MEMORANDUM

TO: Ms. Sarah Porter, City of New Bedford Conservation Agent
FROM: Scott Turner, PE, Nitsch Engineering 
DATE: May 17, 2019
RE: 100 Duchaine Boulevard, Parallel Products, DEP# SE49-0771, Raingarden

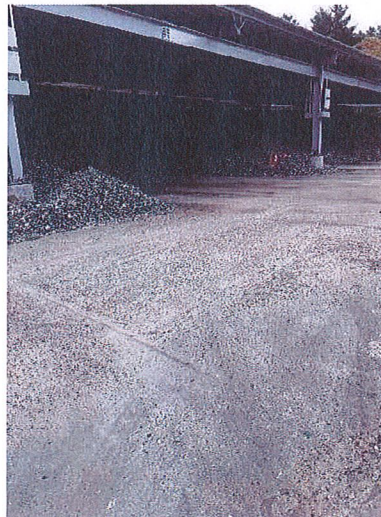
- 5.) There appears to be shallow “trenches” that were created on the south side of the rain garden. These “trenches” appear to be directing water from the raingardens to the wooded area located to the south of the raingarden. Since they appear lower than the rip-rap overflow, water that is collected in the basin never reaches the rip-rap elevations. (see pictures above and below)
